# Code Technology Committee

## Area of Study – NIST World Trade Center Recommendations

### 2007/2008 Cycle Code changes related to the CTC area of study noted above

#### FILE 2 OF 2

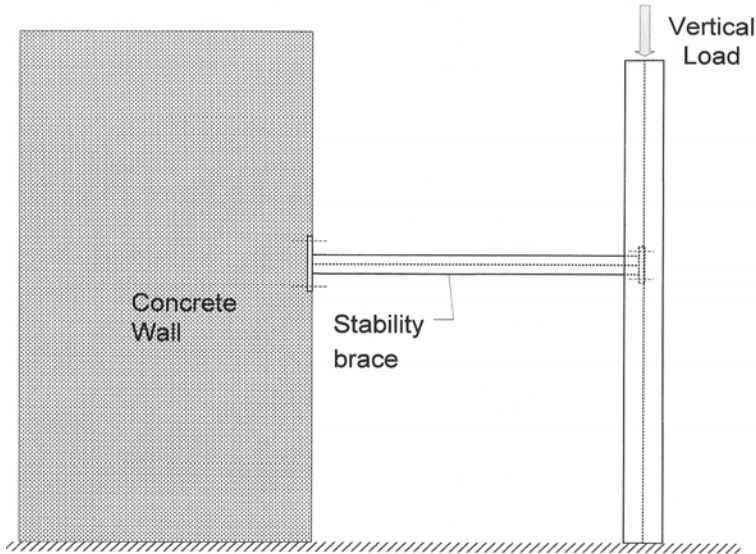
**714.1.1 (Supp) Primary structural frame.** The primary structural frame shall be is the columns and other structural members including the girders, beams, trusses and spandrels having direct connections to the columns and bracing members designed to carry gravity loads. Bracing members that are essential to the vertical stability of the primary structural frame under gravity loading shall be considered part of the primary structural frame whether or not the bracing member carries gravity loads.

**Reason:** The purpose of this code change is to clarify the code provisions regarding what portions of the structure should be considered “primary structural frame”, and therefore, require a fire-resistive rating.

The current language is clear in its intent that bracing members that carry only lateral loads (wind or earthquake) are not required to have a fire-resistive rating. Bracing members that carry vertical (gravity) loads as well as lateral loads are required to have a fire-resistive rating. However, the code is silent on bracing members that contribute to the overall stability of the building under gravity loading, but do not directly carry gravity loads.

The figure below illustrates an example where a brace is used to shorten the effective length of a column, preventing the column from buckling under gravity loads. The brace is not directly carrying gravity loads, but under full design loads, if it were not there, the column would fail (assuming the members are designed to the minimum size allowed). In a fire, the brace could be subjected to the same fire conditions as the column. Yet, under the current language in the code, there is no requirement to protect it. So if the fire causes the brace to fail, regardless of what fire-resistive rating is required for the column, the column will also fail.
